# **The Board of Education of School District No. 43 (Coquitlam)**

## **ADDENDUM NO. 1**

**Tender No. 16-07S**

### **Request for Offers: Coronation Development Site**

CONCEPTUAL ROAD  
ACCESS

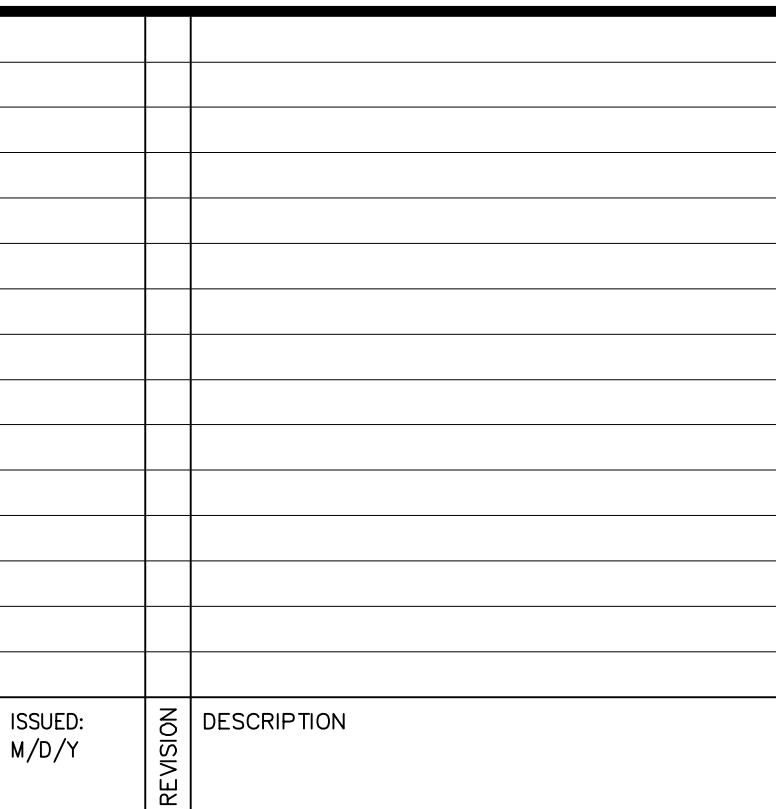
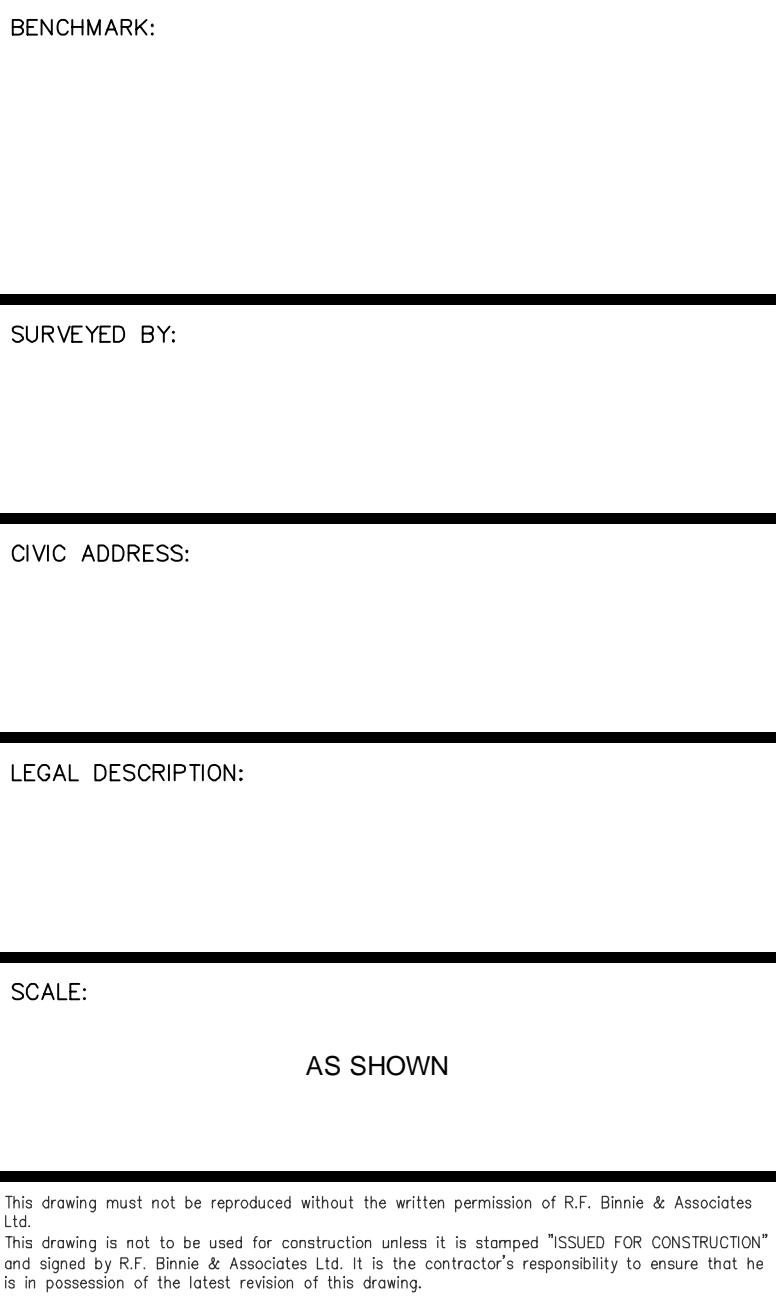
Revised page 8 and additional drawing to Appendix H - Preliminary Servicing Concept for Redevelopment

Conceptual locations and sections for all three possible locations from Barnet Highway are illustrated on drawing 14-790-R1 attached in Appendix H. While new road access may be preferred from Barnet Highway, it is also possible from Runnel Court as shown on drawing 12-446 sheet 2 of 2 attached in Appendix H, subject to further analysis and discussions with the City of Coquitlam.
